## Recall Information Bulletin

No: C10138 Issued: 8/26/2025

Safety Recall C10138 – Electric Park Brake

FEC7K (E16L/E16M), FEC9K (E18L/E18M), FECXK (E18)

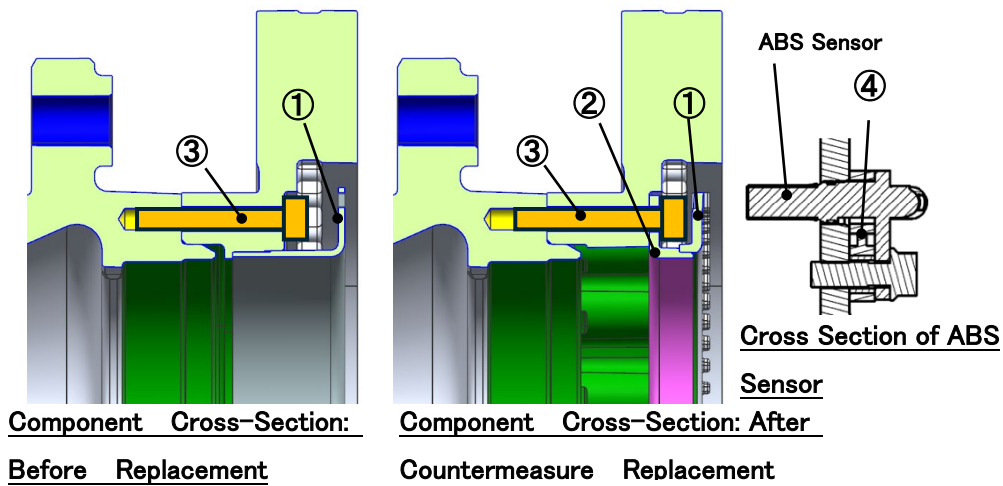
When replacing the brake assembly, ensure the following steps are carried out properly:

- **Disconnect the 12V battery terminals before starting the work.**
- **Avoid applying strong impact to the EPB actuator during brake assembly replacement.**
- **Replace both left and right brake assemblies.**
- **After replacing the brake assembly, follow the service manual procedure to thoroughly bleed air from the brake circuit. (removing trapped air or vapor from the brake lines) Additionally, check the drag torque and confirm that there are no issues.**
- **After connecting the EPB actuator wiring and ABS sensor wiring, reconnect the 12V battery terminals. Then, follow the initial setting procedure outlined in service manual Gr.36EB to reset the EPB actuator operation count.**

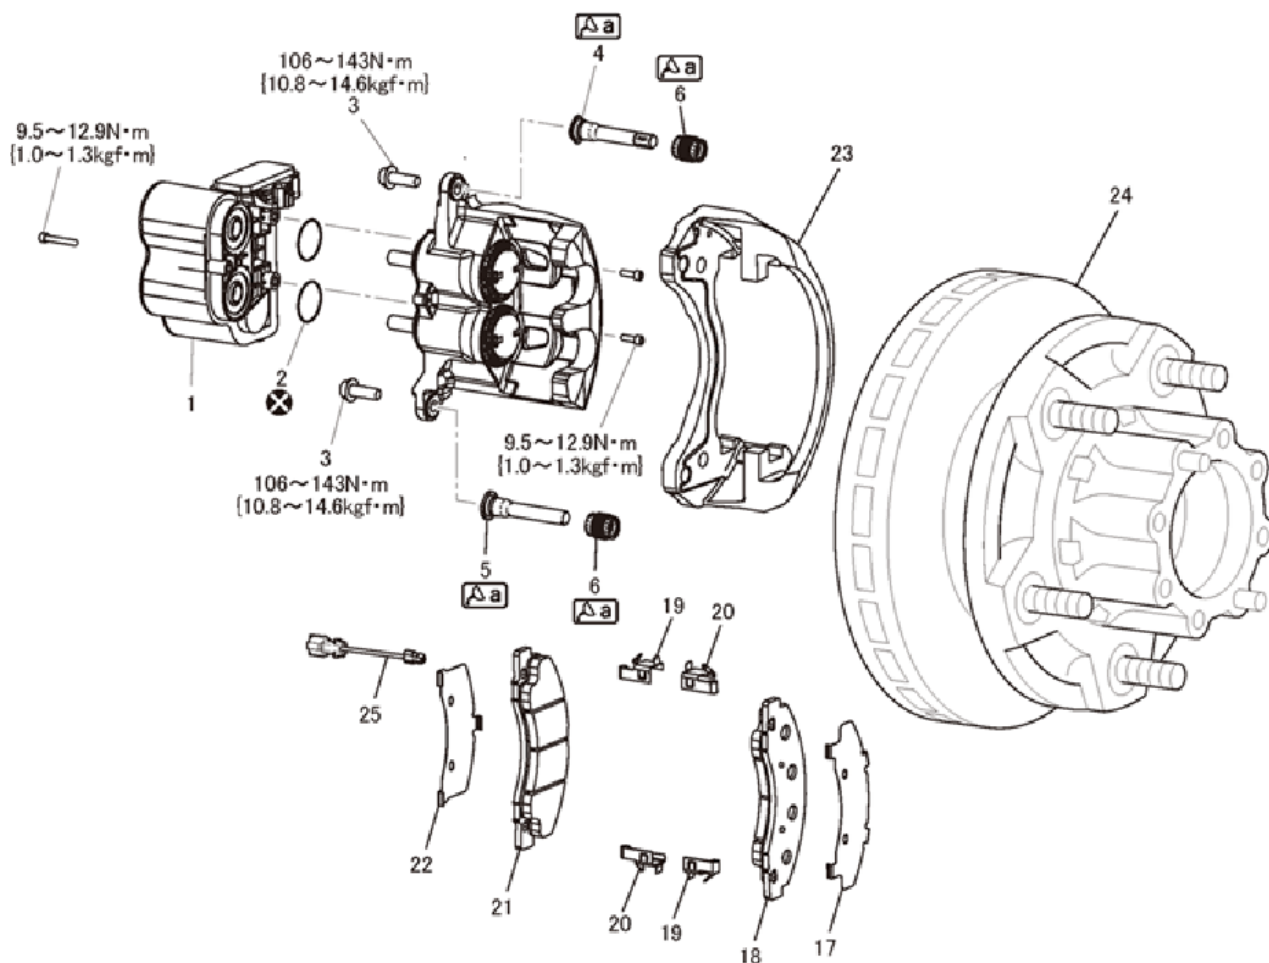
※ Replace only item ①: EPB Actuator and item ②: O-Ring, as shown in the diagram below.

• Rear Left and Right EPB Actuator and O-Ring (Actuator connection area)

- Disconnect the 12V battery terminals before starting the work.
- Avoid applying strong impact to the EPB actuator.
- Replace both left and right EPB actuators.
- Always use a new O-ring for replacement.
- Prevent damage to the O-ring during installation and ensure it is properly positioned.
- After connecting the EPB actuator and ABS sensor wiring, reconnect the 12V battery terminals. Then, follow the initial setting procedure outlined in **service manual Gr.36EB** to reset the EPB actuator operation count.
